-----  
ADDRESS : 340 VALLEY OAK DR SUBDIV: FOREST OAKS PH 3 99LOTS  
CONTRACTOR : H & H CONSTRUCTORS INC PHONE : (910) 486-4864  
OWNER : H & H CONSTRUCTORS INC PHONE : (910) 486-4864  
PARCEL : 01-0536-05- -0028- -40-  
APPL NUMBER: 08-50019665 CP NEW RESIDENTIAL (SFD)  
DIRECTIONS : HWY 27 W TO NURSERY RD TURN LEFT ON  
NURSERY RD LEFT ON LEMUEL BLACK RD LEFT  
ON VALLY OAK INTO FOREST OAKS S/D LOT  
153 JB  
-----

PERMIT: CPSF 00 CP \* SFD

Re: 278909  
153 Forest Oaks Harnett Co., NC

| Job<br>278909 | Truss<br>A02 | Truss Type<br>ROOF TRUSS | Qty<br>9 | Pty<br>1 | 153 Forest Oaks Hamett Co., NC<br>1.0 UNITS AMN<br>1 OF 1<br>Job Reference (optional) | 114394118 |

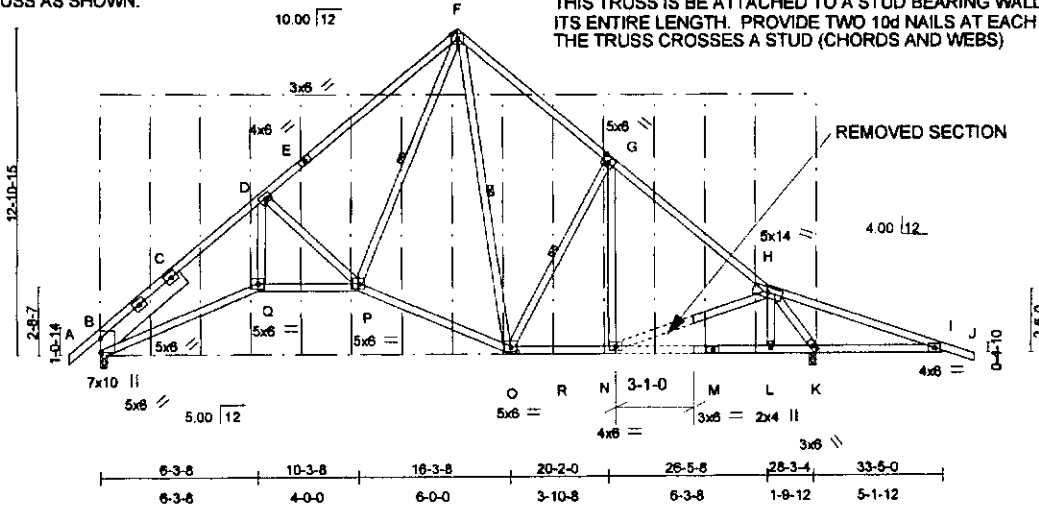
| TYP/SQ  | REQUESTED COMPLETED | INSP RESULT        | DESCRIPTION RESULTS/COMMENTS   |
|---------|---------------------|--------------------|--|
| R425 01 | 9/16/08<br>9/16/08  | DT<br>DA           | FOUR TRADE ROUGH IN VRU #: 001677285<br>1. AO2 trusses not strapped for uplift properly.<br>2. Need fire caulk for dryer vent and at top plate in family room.<br>3. Need nail guards in master closet.<br>4. HVAC line sets not completely installed.<br>Okay to side/insulate. |
| R425 02 | 9/18/08<br>9/18/08  | DT<br>DP           | FOUR TRADE ROUGH IN TIME: 17:00 VRU #: 001678960<br>1. Trusses still not strapped correctly.<br>2. HVAC line sets cannot be fire blocked with rock wool.<br>3. Dryer vent hole not completely caulked.   |

REMOVE 3-1-0 SECTION OF BOTTOM CHORD AND WEB H-N FROM TRUSS AS SHOWN.

THIS TRUSS IS BE ATTACHED TO A STUD BEARING WALL THROUGHOUT ITS ENTIRE LENGTH. PROVIDE TWO 10d NAILS AT EACH LOCATION WHERE THE TRUSS CROSSES A STUD (CHORDS AND WEBS)

| Job<br>278908 | Truss<br>F04 | Truss Type<br>FLOOR | Qty<br>3 | Ply<br>1 | 153 Forest Oaks Hamett Co., NC<br>1.0 UNITS AMN<br>1 OF 1<br>Job Reference (optional) | 114443232 |

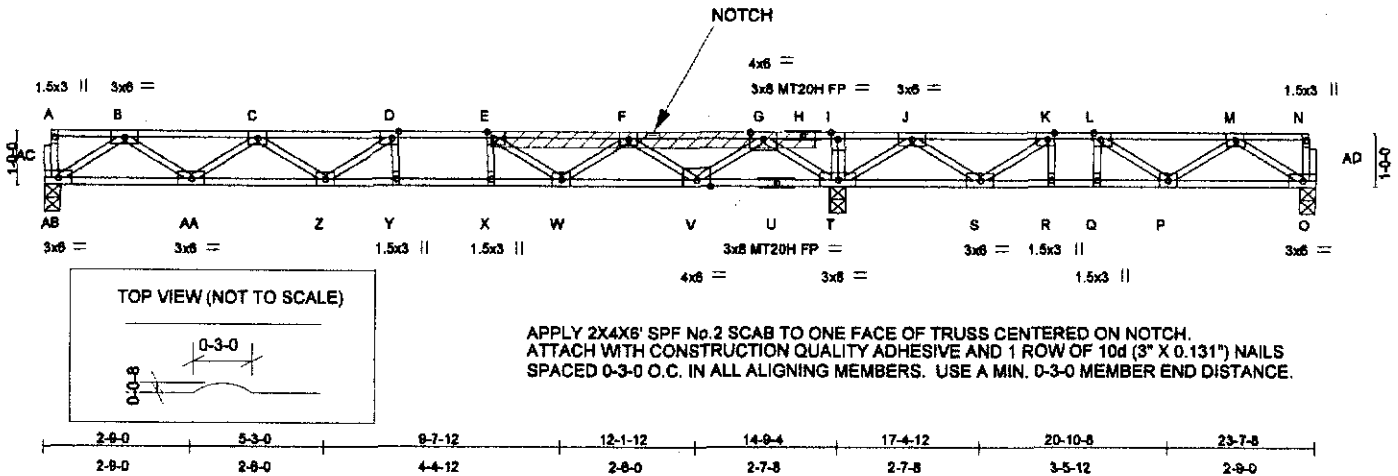
3" WIDE BY 1/2" DEEP NOTCH IN TOP CHORD JUST TO THE RIGHT OF JOINT F.  
NO PLATES OR WEBS ARE DAMAGED.

APPLY 2X4X6" SPF No.2 SCAB TO ONE FACE OF TRUSS CENTERED ON NOTCH.  
ATTACH WITH CONSTRUCTION QUALITY ADHESIVE AND 1 ROW OF 10d (3" X 0.131") NAILS  
SPACED 0-3-0 O.C. IN ALL ALIGNING MEMBERS. USE A MIN. 0-3-0 MEMBER END DISTANCE.
